1W+1W AB級アンプ (その6.1 1/4)

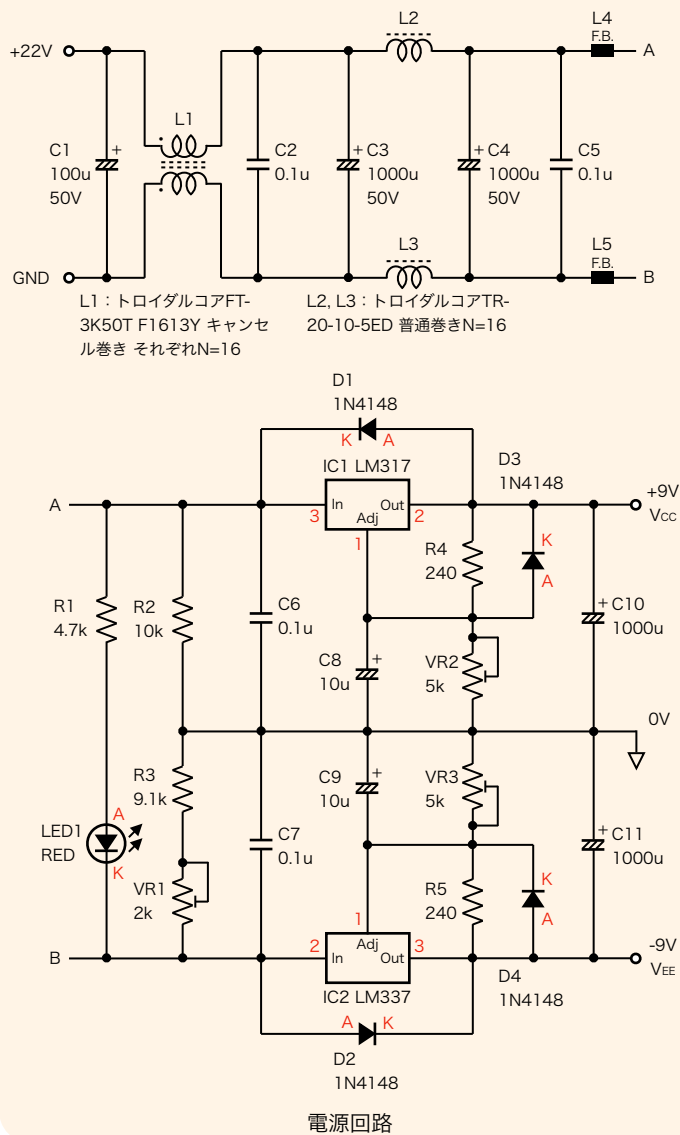
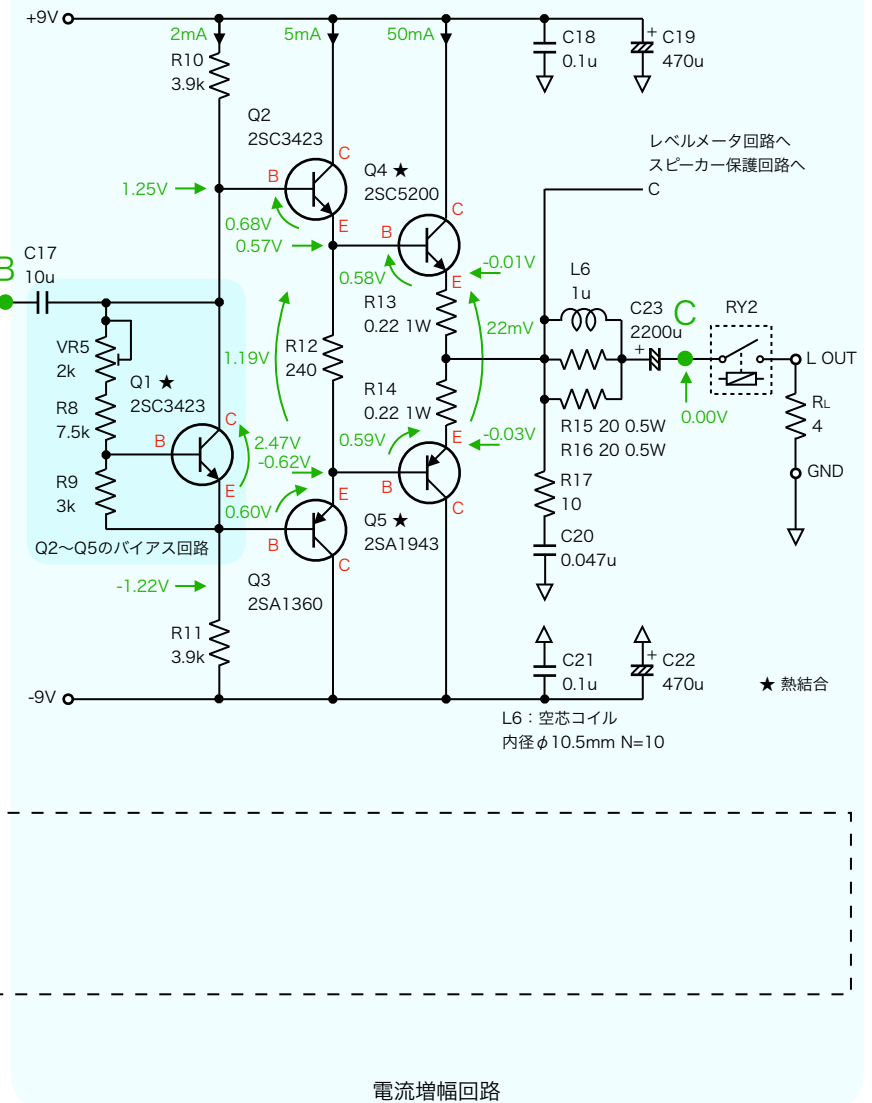
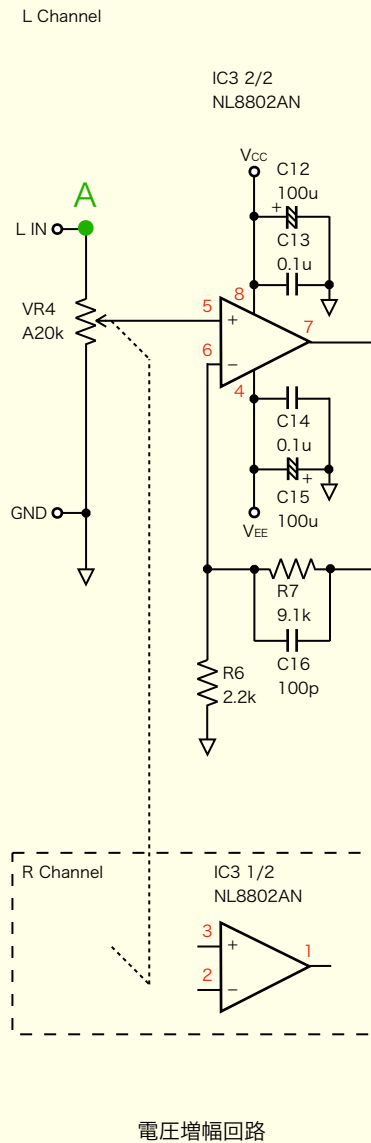
(その6から6.1への変更点) 電源電圧 +20V→+22V, $V_{CC} \cdot V_{EE} \pm 8V \rightarrow \pm 9V$, $R10 \cdot R11$ 3.3k→3.9k, $R12$ 220→240, スピーカー保護回路の追加

LM317 $V_{Out} = V_{REF}(1 + VR2/R4)$, $VR2 = R4(V_{Out}/V_{REF} - 1)$, $V_{REF} = 1.25V$
 V_{Out} を9Vにする場合 $VR2 = 240(9/1.25 - 1) = 1,488\Omega$... $VR3$ も同じ
